UNITED STATES
NUCLEAR REGULATORY COMMISSION
WASHINGTON, D. C. 20555

SAFETY EVALUATION BY THE OFFICE OF NUCLEAR REACTOR REGULATION
RELATING TO THE UPPER REACTOR BUILDING AND NON-SAFETY ARCHITECTURAL
COMPONENTS SUBJECTED TO TORNADO-WIND LOADING
ITEMS 1 AND 11 OF SEP TOPIC III-2
GPU NUCLEAR CORPORATION
OYSTER CREEK NUCLEAR GENERATING STATION
DOCKET NO. 50-219

FIGURE 1

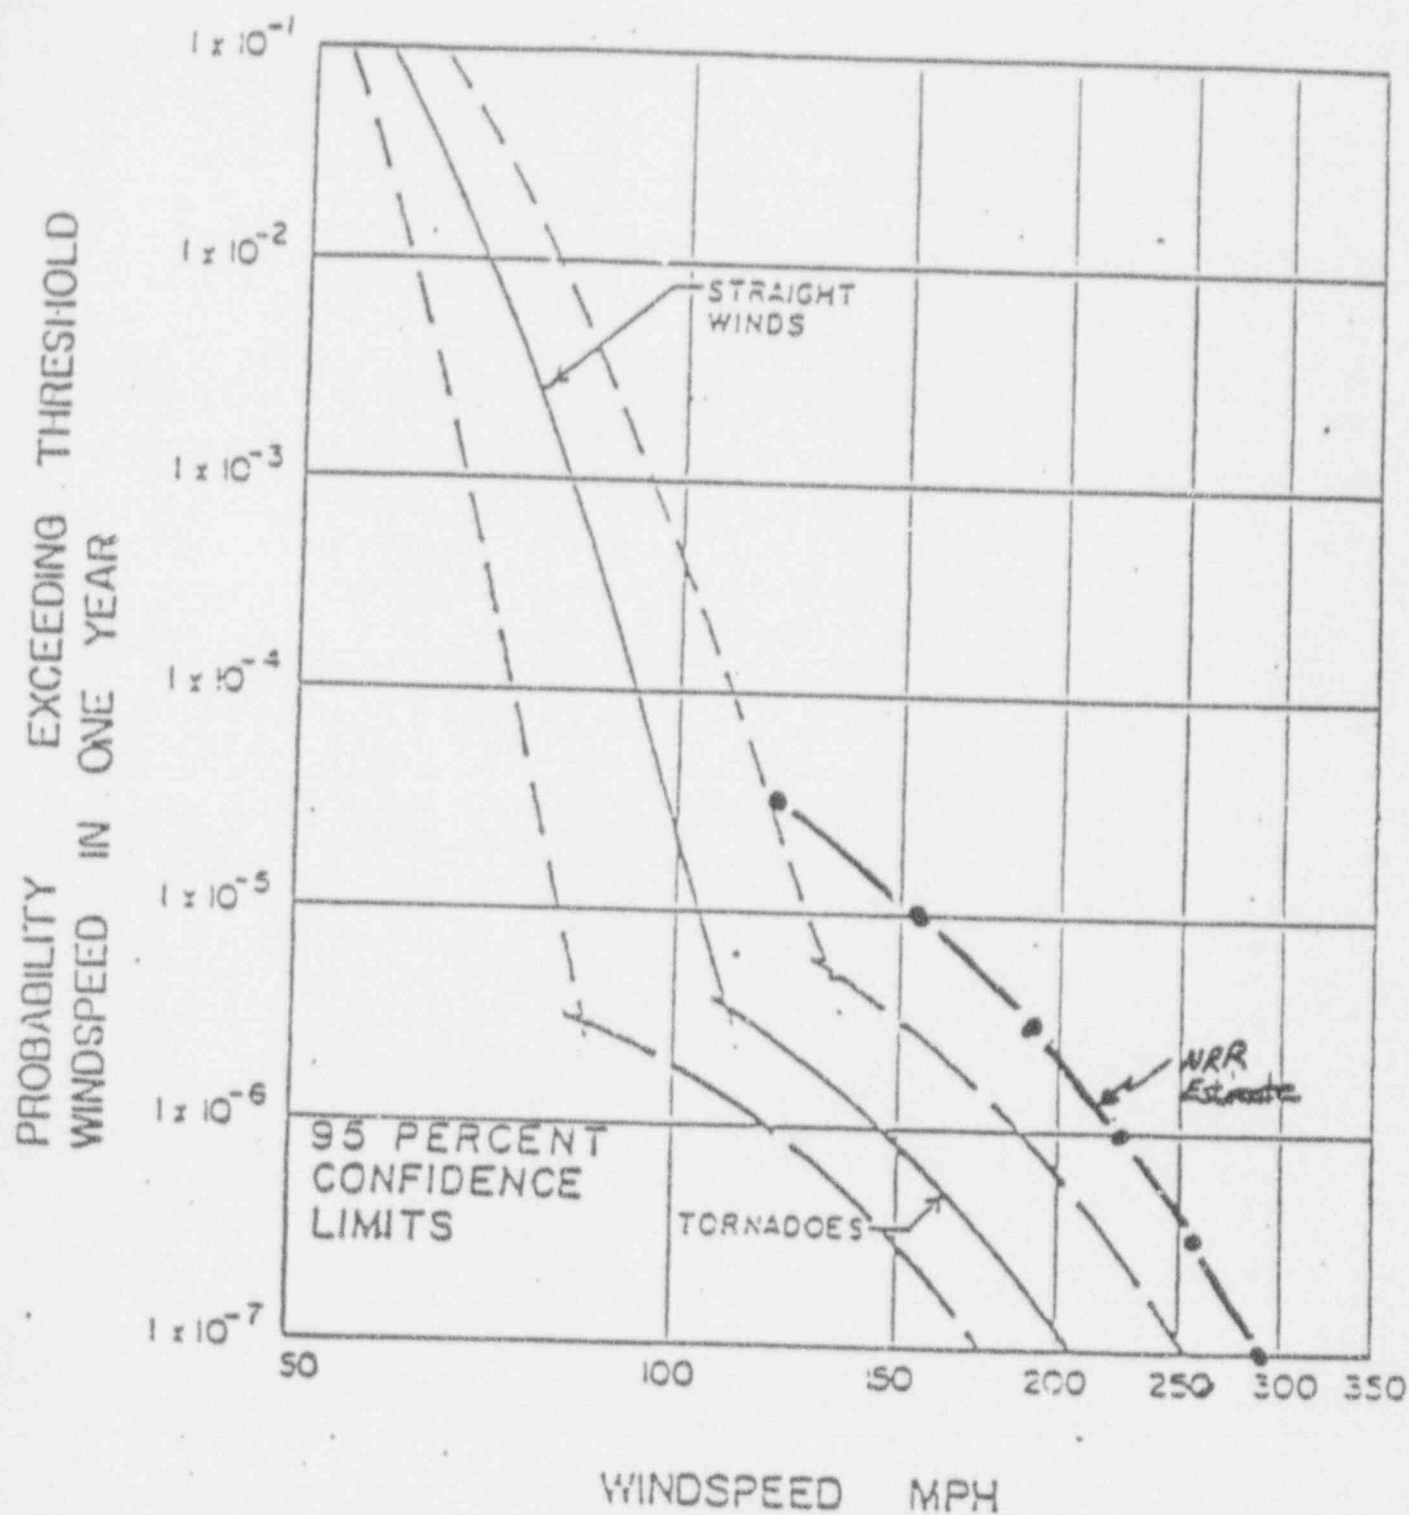
In the Integrated Plant Safety Assessment (IPSA-Ref. 1), the staff indicated that the roof framing of the upper portion of the Reactor building is likely to be structurally unstable at tornado-wind velocities in excess of 164 km/h (102 mi/h). By NRC staff estimate (Fig. 1), this wind velocity corresponds to the annual probability of exceedance (PE) of 5×10^{-3} . For the SEP plants, the staff has accepted the tornado-wind velocities corresponding to the PE lower than 10^{-5} . In the cover letter to the IPSA (Ref. 1), the staff requested the licensee to re-evaluate the structure and to assess if any modification to the structure would be needed to increase its capability.
